To: Newton Board of Aldermen
From: Stephen J. Buchbinder, Esquire
Re: The Station at Riverside/Special Permit Petition #258-12
Date: November 13, 2012

Re: Station at Riverside Redevelopment
Response To Alderman Comments
October 2012 LUC Hearing

Re: Station at Riverside Redevelopment
Response To Alderman Comments
October 2012 LUC Hearing

MBTA
GARAGE PLANS
LEVELS 1 & 2

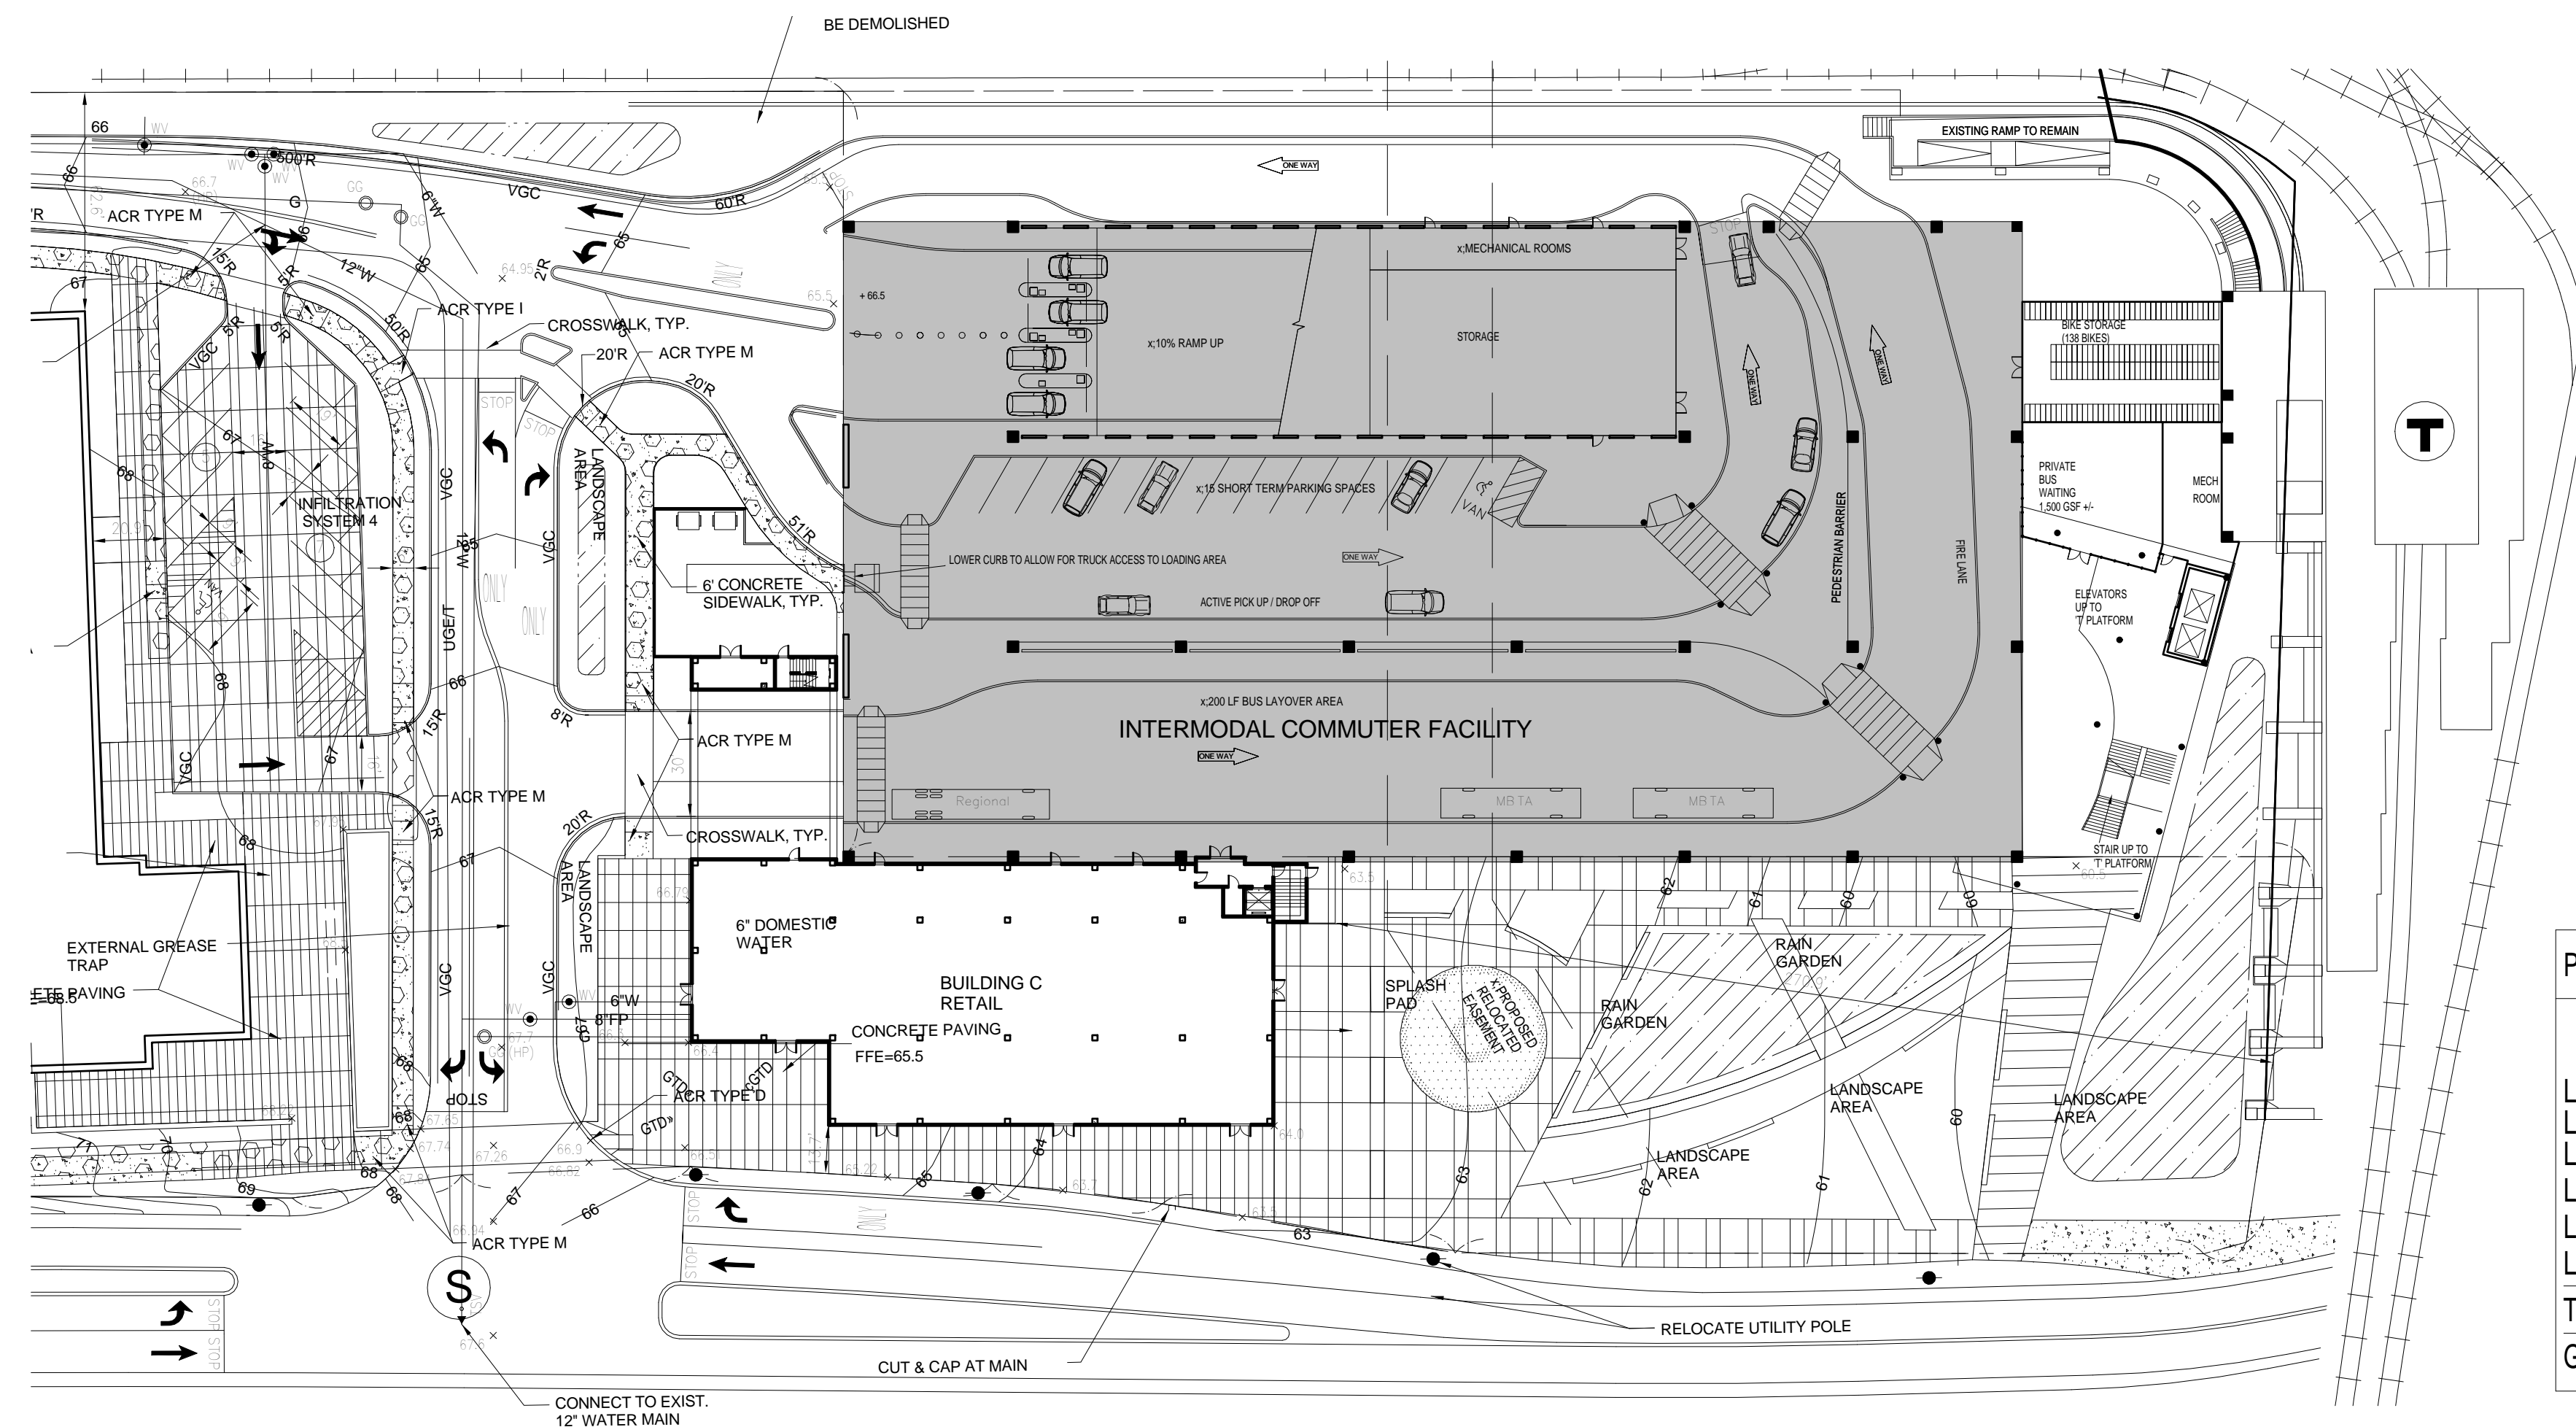
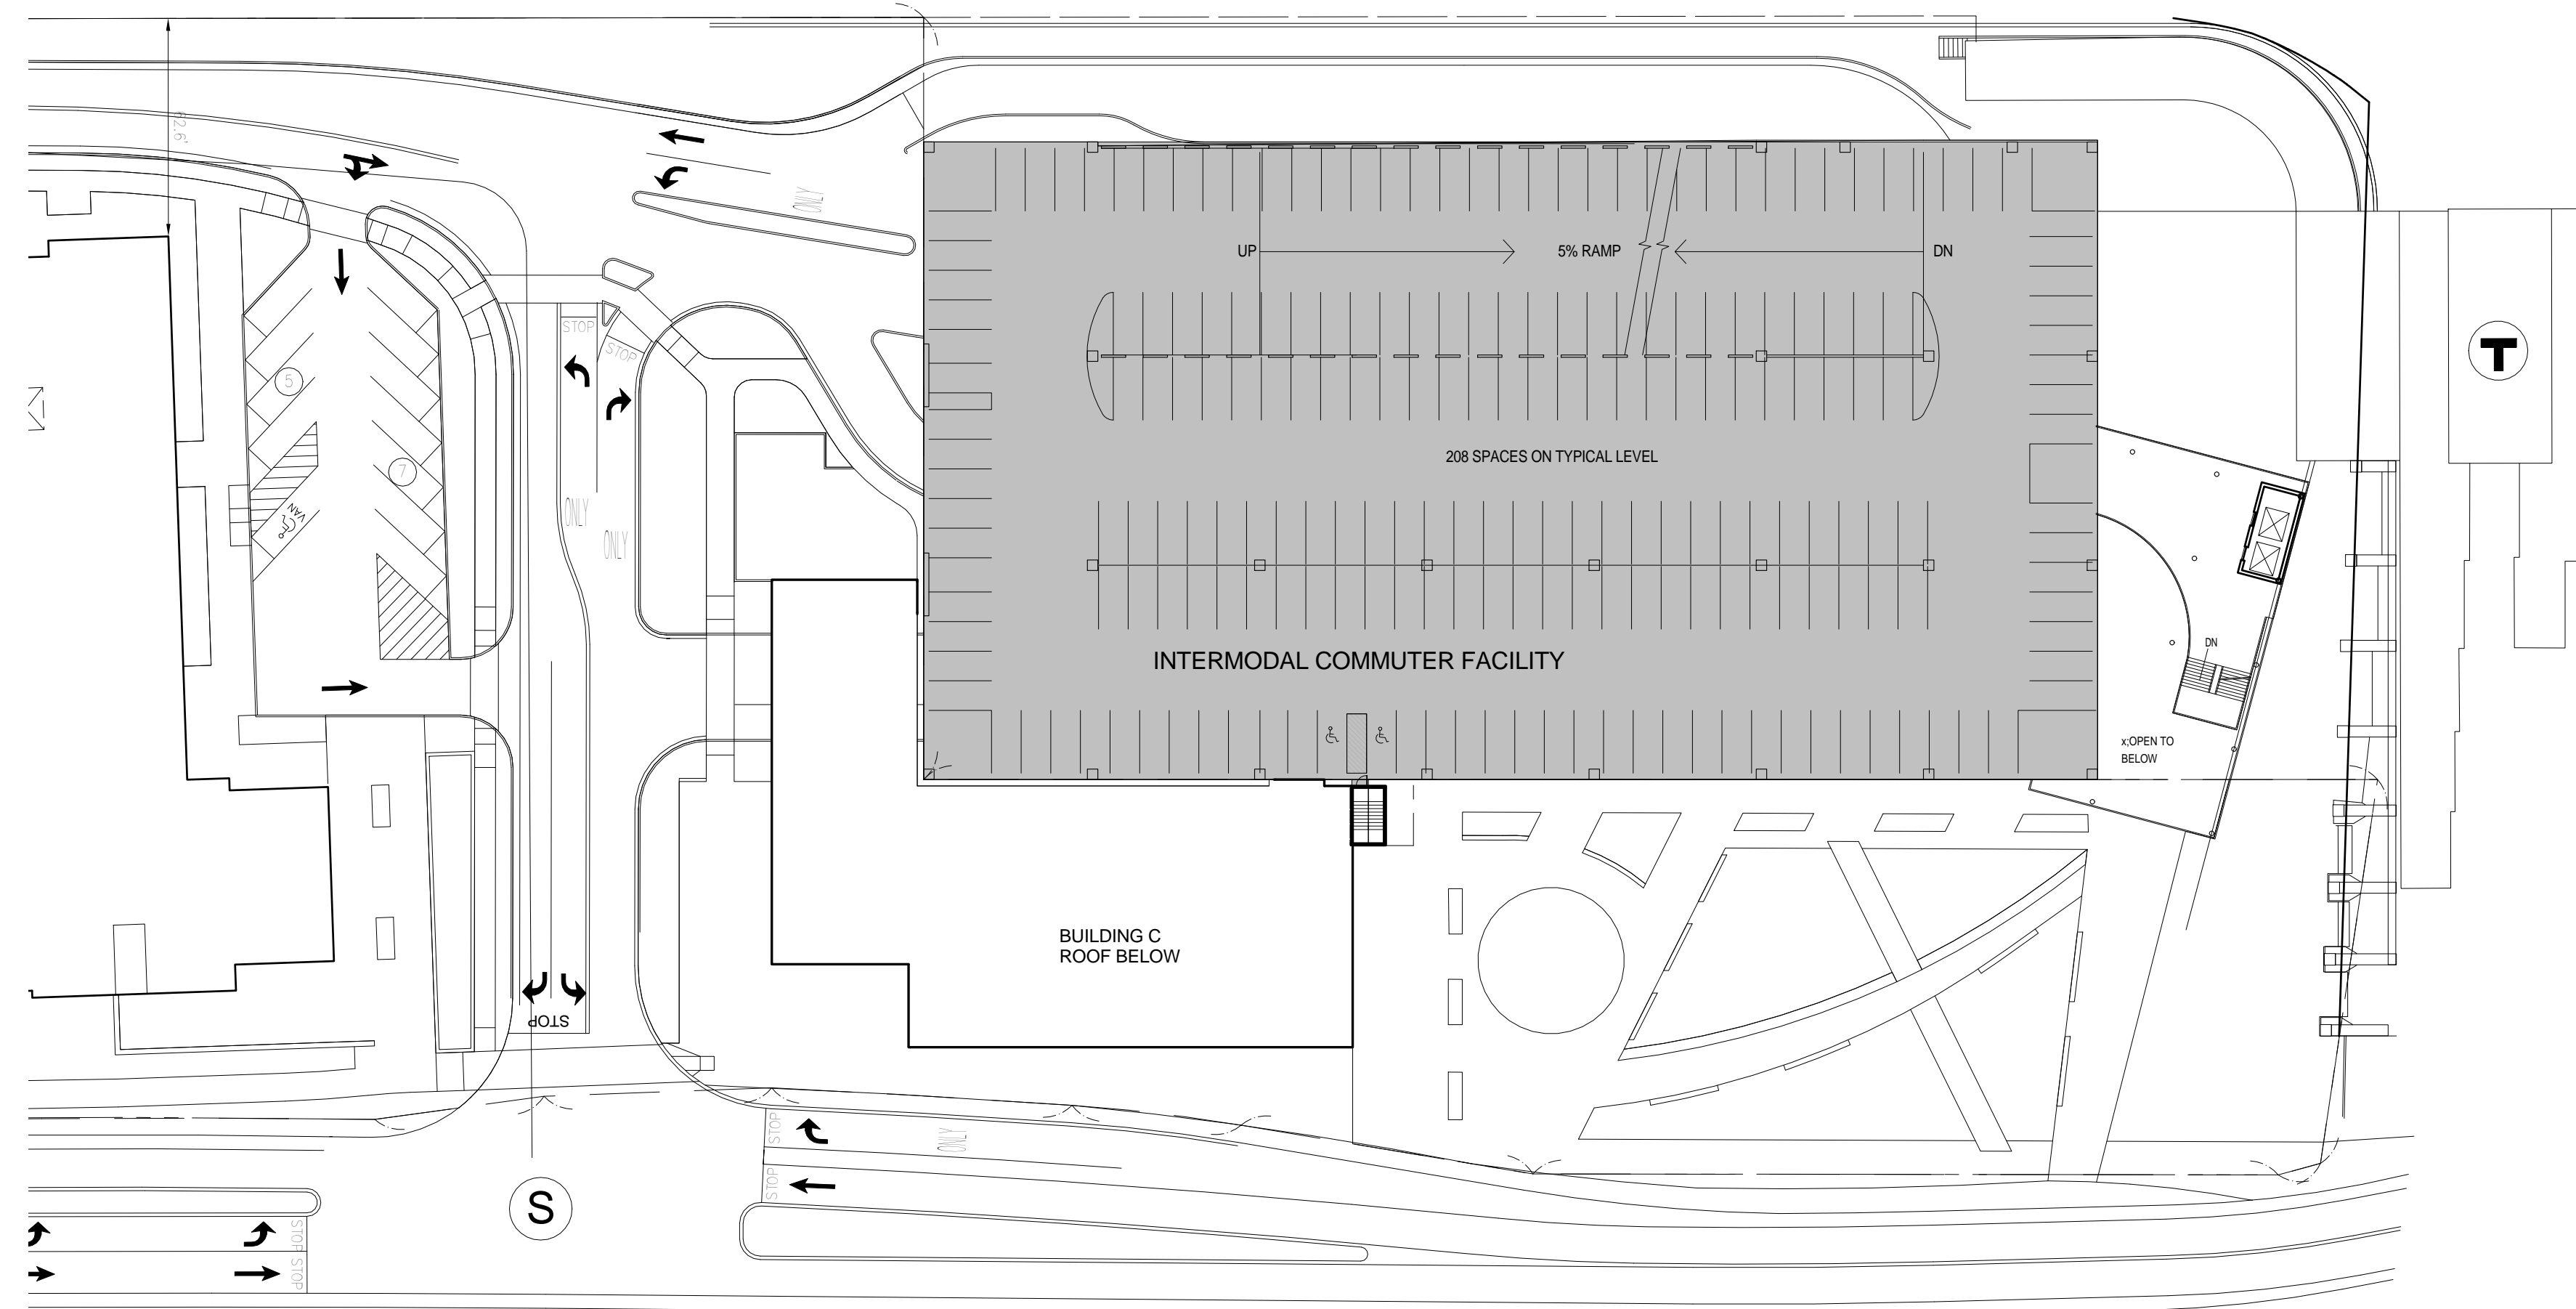
Where will current cars parking to use the T go during construction (Albright)

During the construction of the garage, approximately 625 spaces will be provided for the commuters, a reduction of roughly 335 spaces. As VHB's parking analysis shows, about 300 - 350 spaces of the 960 spaces available are typically empty, except during Red Sox games. At those times, the overflow parking would be directed to other T facilities (i.e., Woodland).

Attachement A - (From 2012 TIAS)
Conceptual Signage Plan
Option A
The Station at Riverside
Newton, Massachusetts

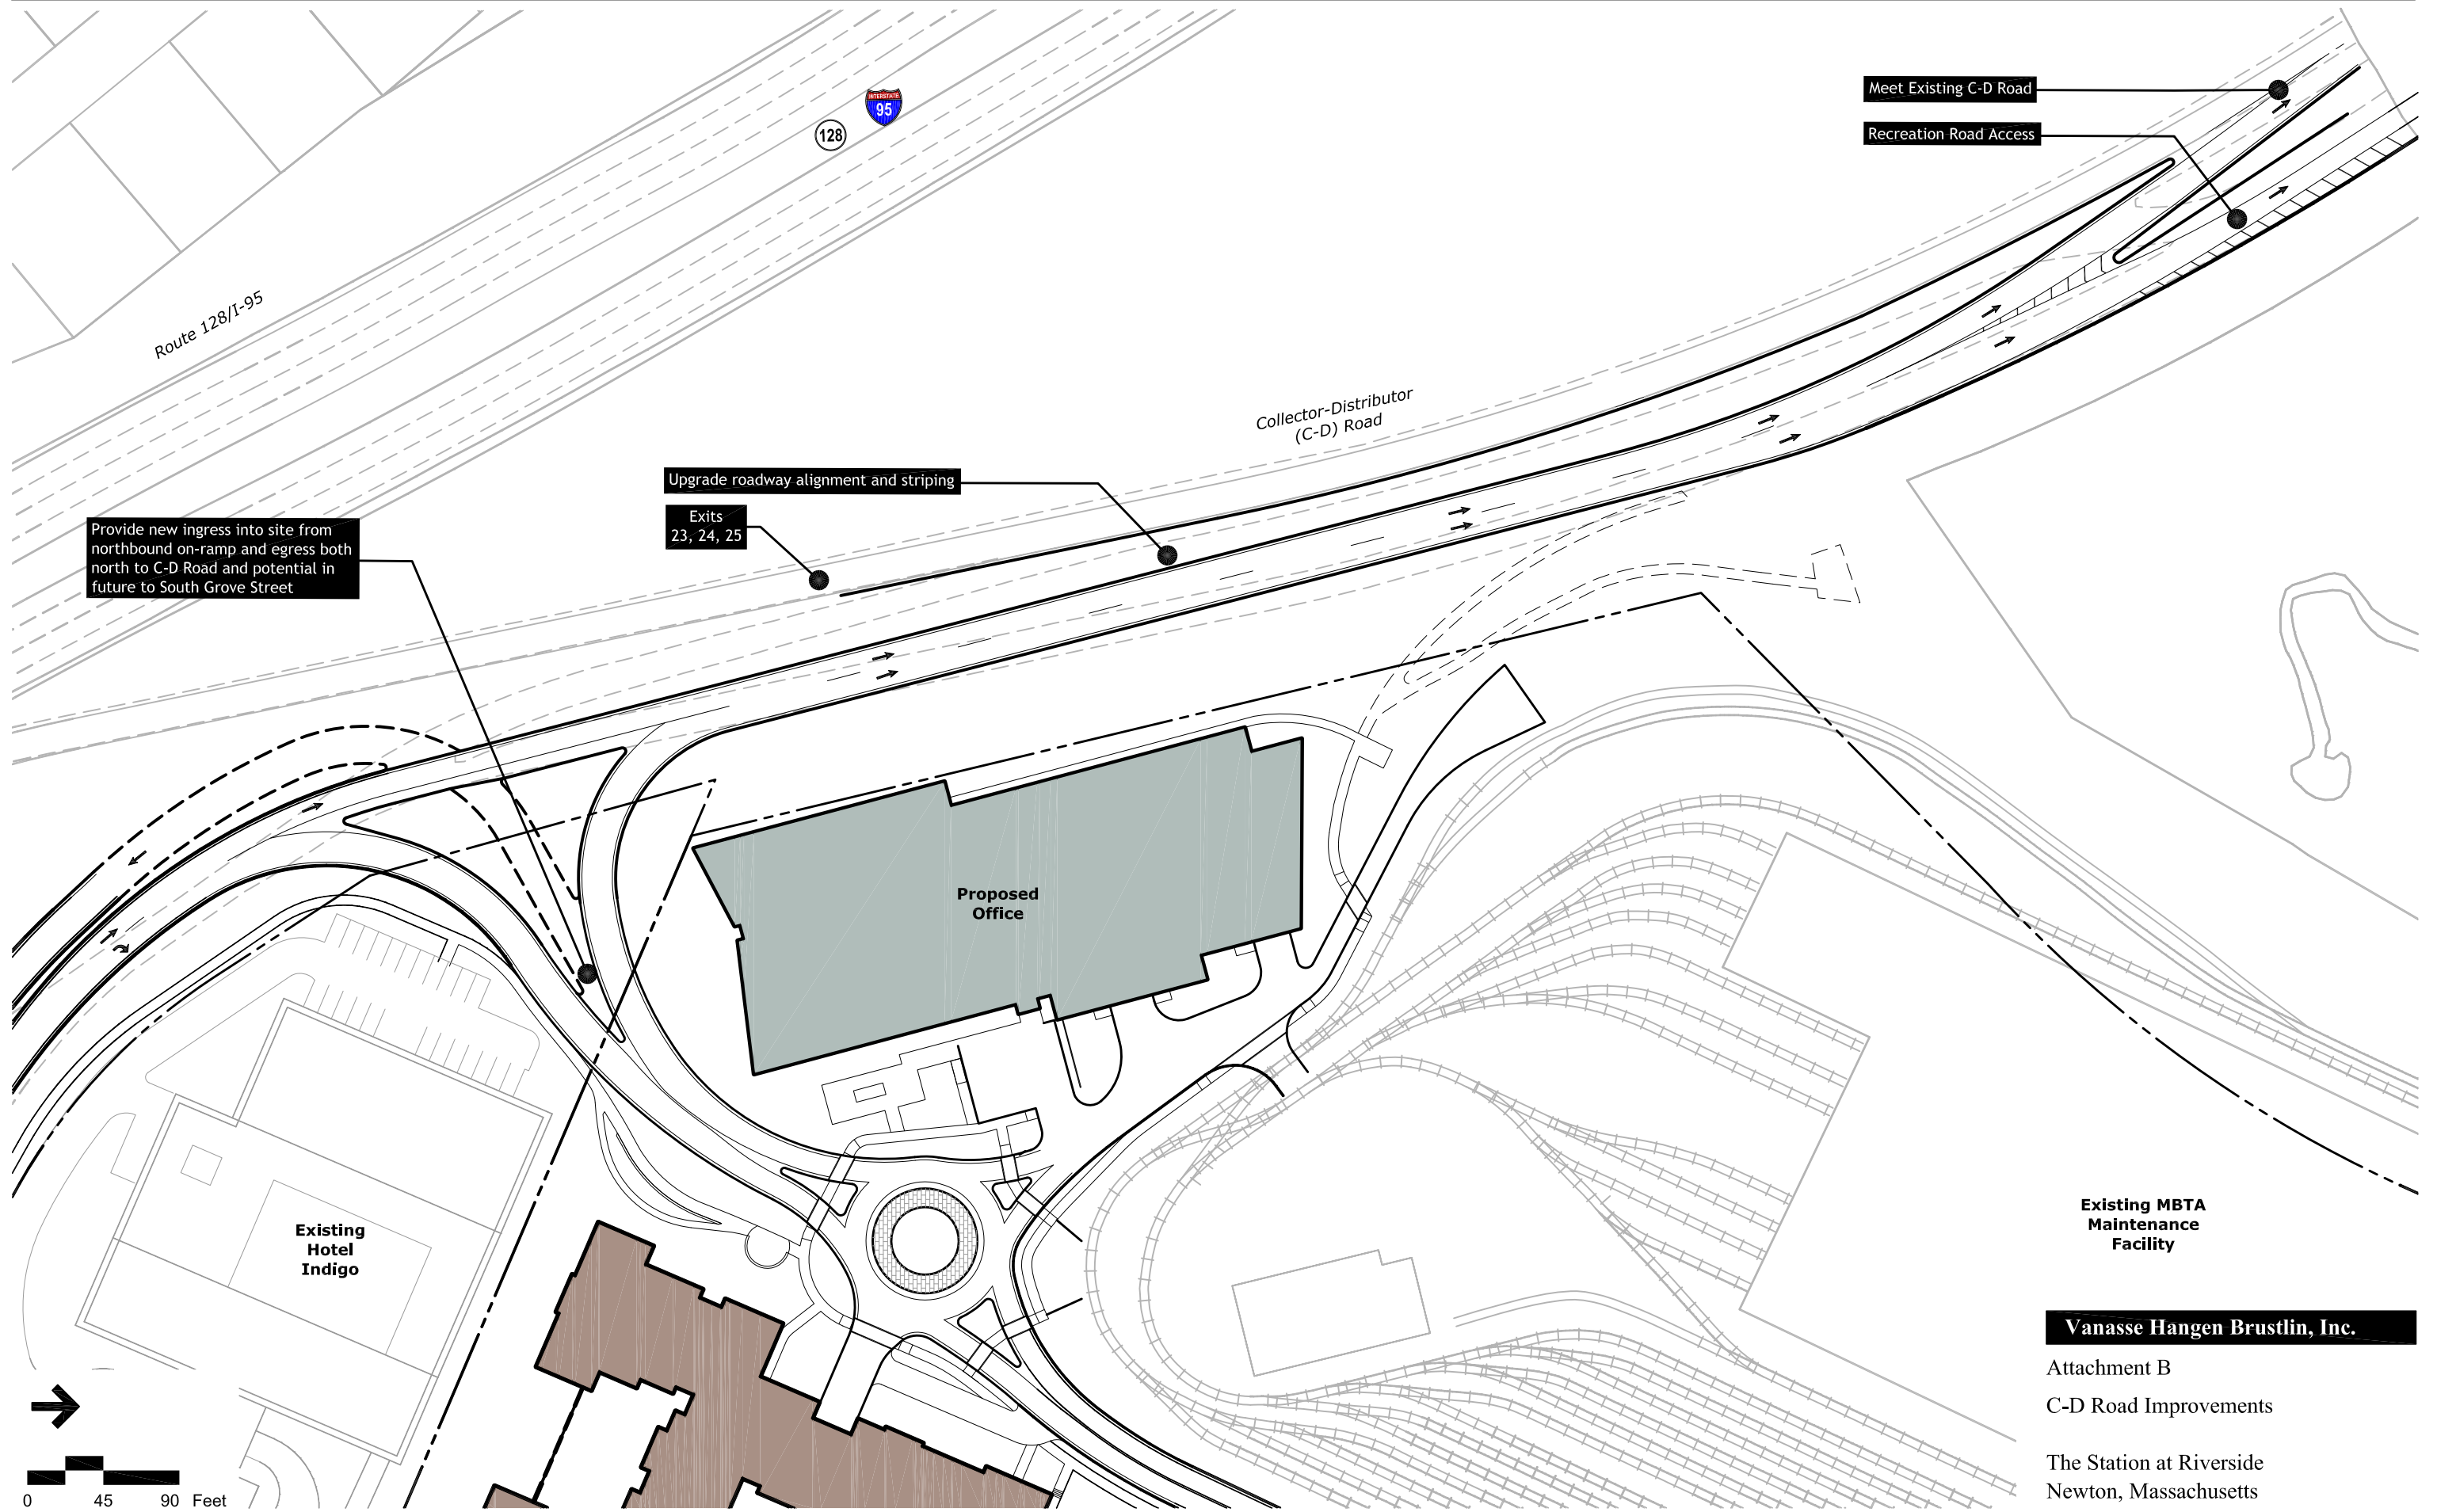
Comment: *How will we encourage people to use the CD Connector access? (Laredo)*

Response: Under the proposed access plan, priority has been given to motorists who choose to enter the site from the CD Road access. Access to both the residential and office components of the project is more direct and a shorter distance from the highway by using the CD Road access. Access to the retail, community center, and the MBTA Garage is prioritized from the CD Road as direct access to all site facilities is free flow from the CD Road access. In contrast, access to the site from Grove Street requires movement through a traffic signal and the primary intersection on site in front

of the MBTA garage will be signed as STOP control on the northbound approach to give priority to the CD Road accessing motorists. In addition, a thorough regional and site way-finding sign plan is proposed to further support the CD Road driveway as the main access to the site (Attachment A which is Figure 26 from the February TIAS).
